## Issue List

## NCANG Repair Bldg 51 (Charlotte, NC)

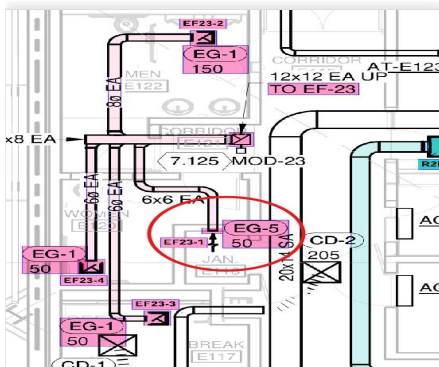
**Issue Name :** EF-23 High Flow  
**Description :** EF-23 is 37% above design (407 CFM ACTUAL / 300 CFM DESIGN) and requires a sheave change to reduce flow. Motor sheave is on the lowest setting. Unable to balance due to a diffuser missing as well.  
**Created By :** National TAB                      **Assigned To :** National TAB - Antonio Flores-De La Cruz  
**Status :** Open  
**Priority :** Urgent                                      **Asset Tag :**  
**Originated Date :** 02/12/2026 - Antonio Flores-De La Cruz - National TAB

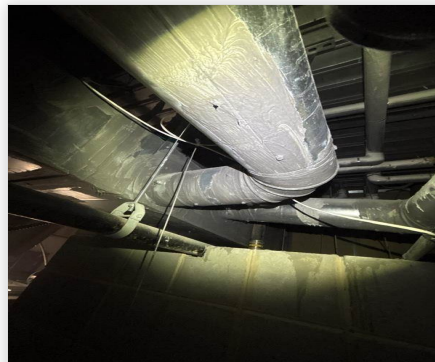
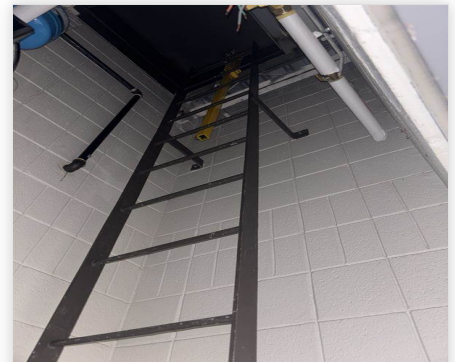
**Issue Name :** EF-23 Missing Grille  
**Description :** Grille EF-23-1 in JANITORS E118 is not installed.  
**Created By :** National TAB  
**Assigned To :** National TAB - Antonio Flores-De La Cruz  
**Status :** Open  
**Priority :** High  
**Asset Tag :**  
**Originated Date :** 02/12/2026 - Antonio Flores-De La Cruz - National TAB

- **03/30/2026 National TAB - Antonio Flores-De La Cruz**
  - Will not be installed

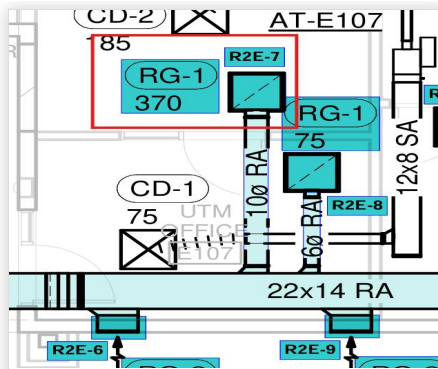
**Issue Name :** EF-26 Low Flow  
**Description :** EF-26 is at 66% of design (99 CFM ACTUAL / 150 CFM DESIGN). The speed dial is at max. A possible cause could be a partially opened exhaust motorized damper. It was found that there is a damper at the takeoff and one at the arm of the equipment where the duct connects, which may add resistance to the system.

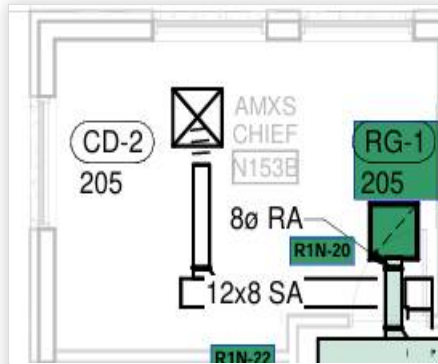
**Issue Name :** Missing Damper for Return Grille  
**Description :** Return Grille R2E-7 in E107A is missing the damper to balance.  
**Created By :** National TAB **Assigned To :** National TAB - Antonio Flores-De La Cruz  
**Status :** Open  
**Priority :** Urgent **Asset Tag :**  
**Originated Date :** 03/02/2026 - Antonio Flores-De La Cruz - National TAB

- **04/01/2026 National TAB - Antonio Flores-De La Cruz**
  - Installed but during balancing, flow is being restricted. Possible cause could be the transition at the collar reducing flow.

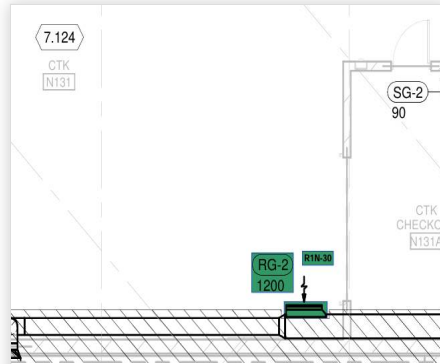
**Issue Name :** Missing Return Damper in ROOM AXMS CHIEF N153B  
**Description :** Grille R1N-20 is missing the damper to TAB.  
**Created By :** National TAB                      **Assigned To :** National TAB - Antonio Flores-De La Cruz  
**Status :** Open  
**Priority :** Urgent                                      **Asset Tag :**  
**Originated Date :** 03/03/2026 - Antonio Flores-De La Cruz - National TAB

- **04/02/2026 National TAB - Antonio Flores-De La Cruz**
  - Not Installed.

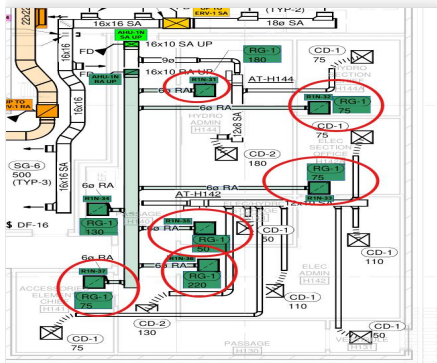
**Issue Name :** Missing Return Damper in ROOM CTK N131  
**Description :** Grille R1N-30 is missing the damper to TAB.  
**Created By :** National TAB                      **Assigned To :** National TAB - Antonio Flores-De La Cruz  
**Status :** Open  
**Priority :** Urgent                                      **Asset Tag :**  
**Originated Date :** 03/03/2026 - Antonio Flores-De La Cruz - National TAB
